AEP-NRC-2021-28  
10 CFR 50.90

Donald C. Cook Nuclear Plant Unit 2  
License Amendment Request Regarding a Change to the Reactor Coolant System Pressure and  
Temperature Limits and Low Temperature Overpressure Protection (LTOP) System

Donald C. Cook Nuclear Plant Unit 2 Technical Specification Pages  
Marked To Show Proposed Changes

Figure 3.4.3-1 (page 1 of 1)  
Reactor Coolant System Pressure versus Temperature Limits -  
Heatup Limit, Criticality Limit, and Leak Test Limit  
(Applicable for service period up to 32.48 EFPY and during vacuum fill)

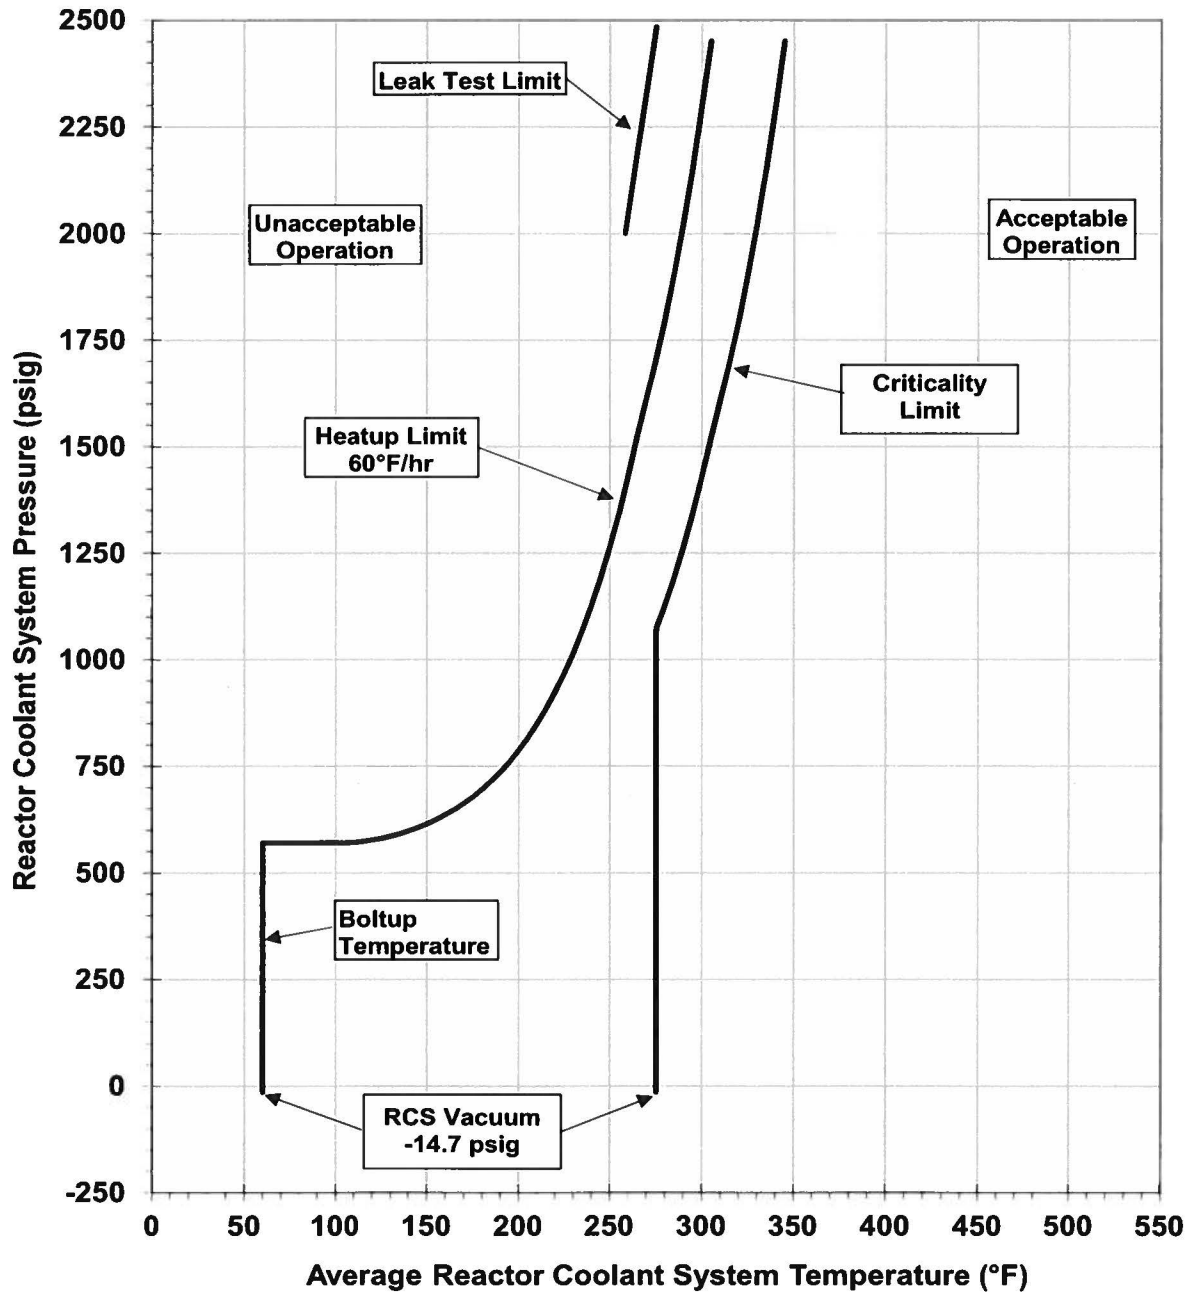
As expected, the revised curves are more restrictive in some operating regions than the existing ones, due to the effects of increased neutron fluence over the life of the reactor vessel, and the associated increase in  $RT_{NDT}$  at the  $\frac{1}{4}$  thickness (1/4T) and  $\frac{3}{4}$  thickness (3/4T) locations. Although the revised curves are more restrictive in some operating regions, the current technical specifications are conservative for today's operation and will be from now until the amendment is approved. This would include TS 3.4.6 Note 2 and the 152°F limit on RCP operation. The new curves were developed using the standard Westinghouse methodologies which have been previously reviewed and approved by the NRC for other licensees.

Replace the existing TS Figure 3.4.3-1 and Figure 3.4.3-2 with the proposed TS Figure 3.4.3-1 and Figure 3.4.3-2 as shown in Enclosure 3.

This change replaces the CNP Unit 2 RCS P/T curves applicable up to 32 EFY with curves applicable up to 48 EFY and reflects the analysis in Enclosure 5 to this letter.
